**MUNICIPALITY OF ANCHORAGE
PLANNING DEPARTMENT
MEMORANDUM**

Case 2011 - 013 Conditional Use for a Planned Unit Development

PLANNING DEPARTMENT
PLANNING STAFF ANALYSIS
CONDITIONAL USE

<u>DATE:</u>	February 7 , 2011
<u>CASE NO.:</u>	2011-013
<u>APPLICANT:</u>	The Petersen Group, represented by Lantech, Inc.
<u>REQUEST:</u>	Final Conditional Use for a Residential Planned Unit Development (PUD) in the R-1A District in accordance with AMC 21.50.020 and 21.50.130 A., B. and C.
<u>LOCATION:</u>	Tract 1 Kincaid Estates
<u>SITE ADDRESS:</u>	9101 Westpark Drive
<u>COMMUNITY COUNCIL:</u>	Sand Lake
<u>TAX NUMBER:</u>	011-291-21

SITE PLAN OF
Solara at West Park
Subdivision
238 UNITS

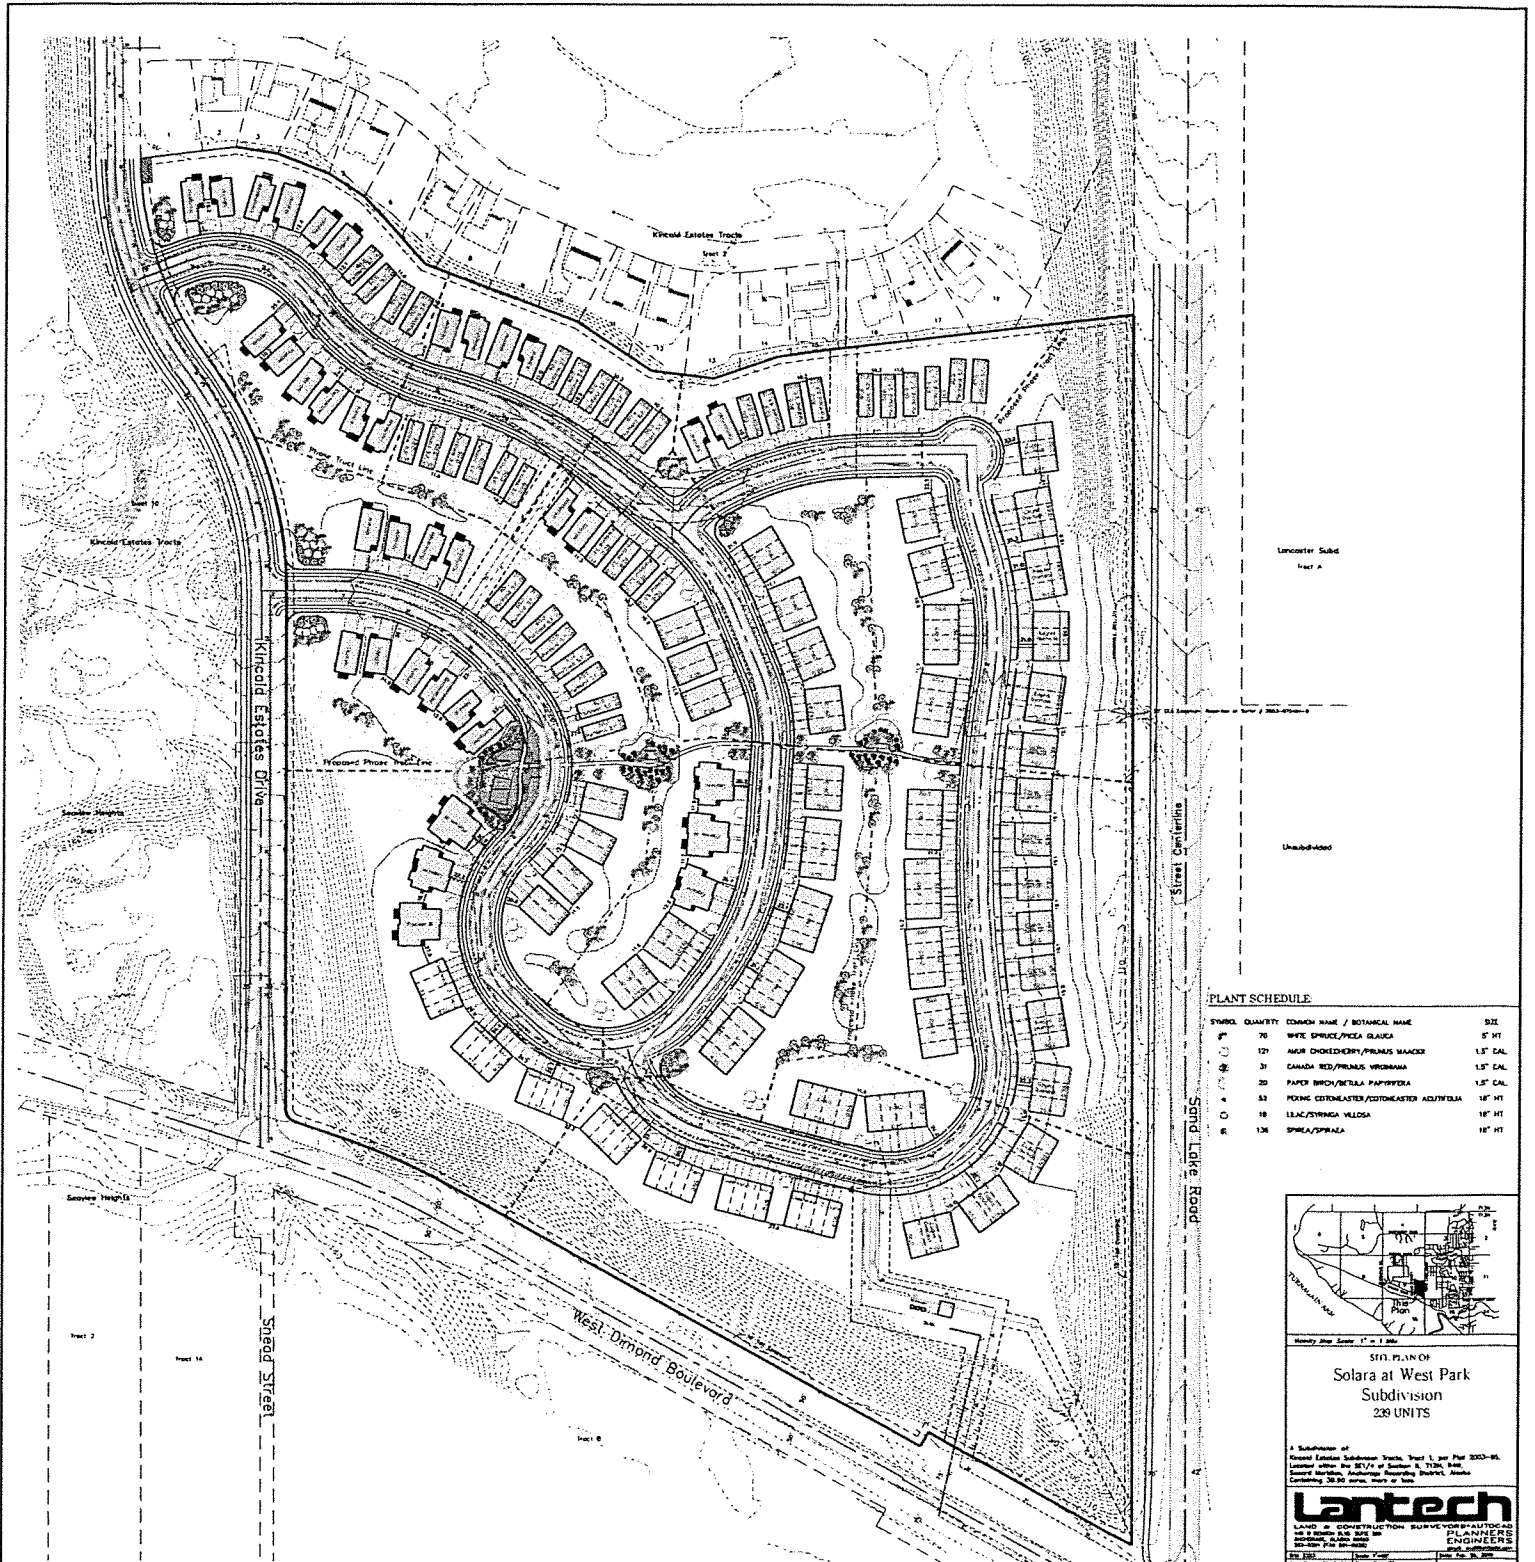
Snow storage areas are shown on the phasing plan. Snow storage cannot be in areas of required parking or required landscaping, and storage areas need to be a minimum of eight feet by eight feet. Some snow storage areas shown on the plan may not be 100 percent accessible as they are behind large mailbox clusters. The

applicant should commit to a snow hauling plan as well, if on site snow storage is to be temporary, or if 20 percent snow storage area cannot be accommodated on site.

The petitioner intends to retain the existing vegetated area along the property boundaries. However, because this existing vegetation is almost all deciduous, some evergreen trees need to be added. Landscaping internal to the property will be discussed as part of the final landscape plan, but a concept plan indicating some minimum landscaping should be proposed.

The site is approximately 40 acres in size. A calculation on the site plan indicates there is a total of 786,610 square feet or 45 percent (18 acres) of usable open space. Private open space is shown at 199,086 square feet which is 25 percent.

The subdivision to the north, Kincaid Estates Tract 2, has provided a pedestrian connection easement (no sidewalk yet exists) to Tract 1. The site plan for Tract 1 indicates an open area connecting to Tract 2 at the same location, and a pedestrian path is shown.

Structures will have to be reviewed in the site plan of each phase to ensure that the required separation is met. Building footprints may need to be adjusted, or the overall number of units may need to be reduced in order to meet this standard. Structures are not allowed to exceed 35 feet in height.

13. Provide a snow storage calculation which demonstrates 20 percent of total street area is available for snow storage. Snow storage areas shall be a minimum 8 feet on any dimension. Snow storage is not allowed in areas of required landscaping or required parking.
14. With the site plan for phase one, the applicant shall include a fence plan for all five phases indicating a common design theme (style, material, color, etc) for all fences, whether the fence belongs to the homeowners association or to individual unit owners. Title 21.45.110 fence standards shall apply. This information shall be added to the homeowner's documents.
15. Street curbs shall be similar to barrier curbs type 1 or type 3.
